SUNDRY NOTICES AND REPORTS ON WELLS
Do not use this form for proposals to drill or to re-enter an abandoned well. Use form 3160-3 (APD) for such proposals.

8. Well Name and No.
HH SO 8 P2 14H

9. API Well No.
30-015-43931

CVX respectfully respects the ability to change the BOPE rating for the selected well from a 10M system to a 5M system. The max mud weight at 10500' for the pore pressure is a 13.0 ppg. The MAS under these assumptions will be 4788 psi. The attached documents reflect a 5M system BOPE rating and test procedures.

SURFACE WELD HEAD
 UN-27.5 VC THREAD, CHEVRON, SUBSEA

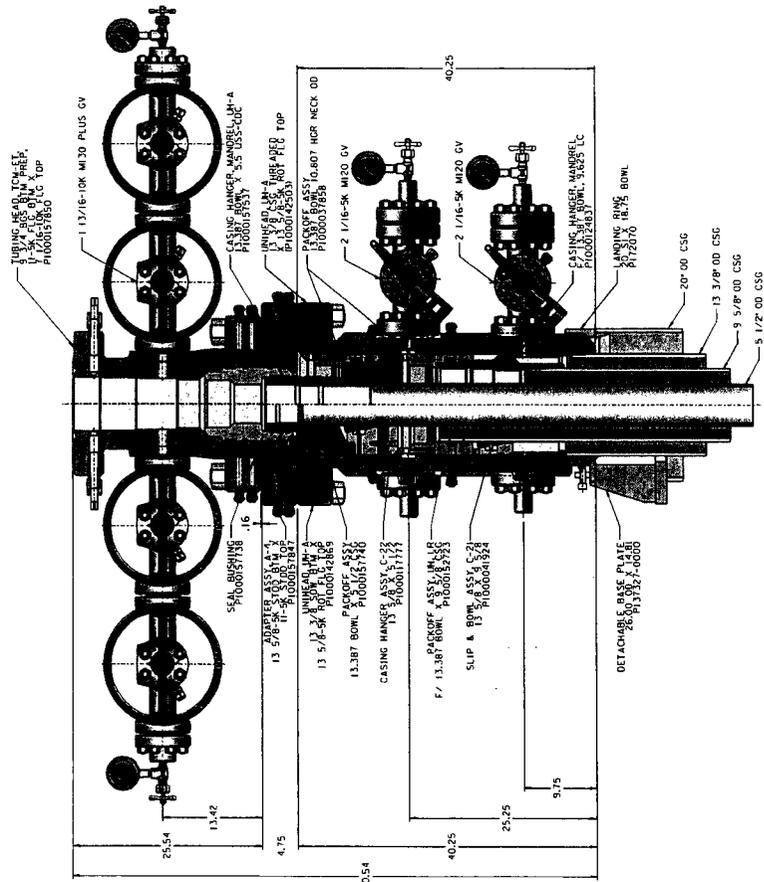
Chevron requests a variance to use a FMC Technologies UH-2 multibowl wellhead, which will be run through the rig floor on surface casing. BOPE will be nipples up and tested after cementing surface casing. Subsequent tests will be performed as needed, not to exceed 30 days. The field report from FMC Technologies and BOP test information will be provided in a subsequent report at the end of the well. Please refer to the attached wellhead schematic.

Operator has proposed a multi-bowl wellhead assembly. This assembly will only be tested when installed on the surface casing. Minimum working pressure of the blowout preventer (BOP) and related equipment (BOPE) required for drilling below the surface casing shoe shall be 5000 (5M) psi.

- a. Wellhead shall be installed by manufacturer's representatives, submit documentation with subsequent sundry.
- b. If the welding is performed by a third party, the manufacturer's representative shall monitor the temperature to verify that it does not exceed the maximum temperature of the seal.
- c. Manufacturer representative shall install the test plug for the initial BOP test.
- d. Operator shall perform the intermediate casing integrity test to 70% of the casing burst. This will test the multi-bowl seals.
- e. If the cement does not circulate and one inch operations would have been possible with a standard wellhead, the well head shall be cut off, cementing operations performed and another wellhead installed.
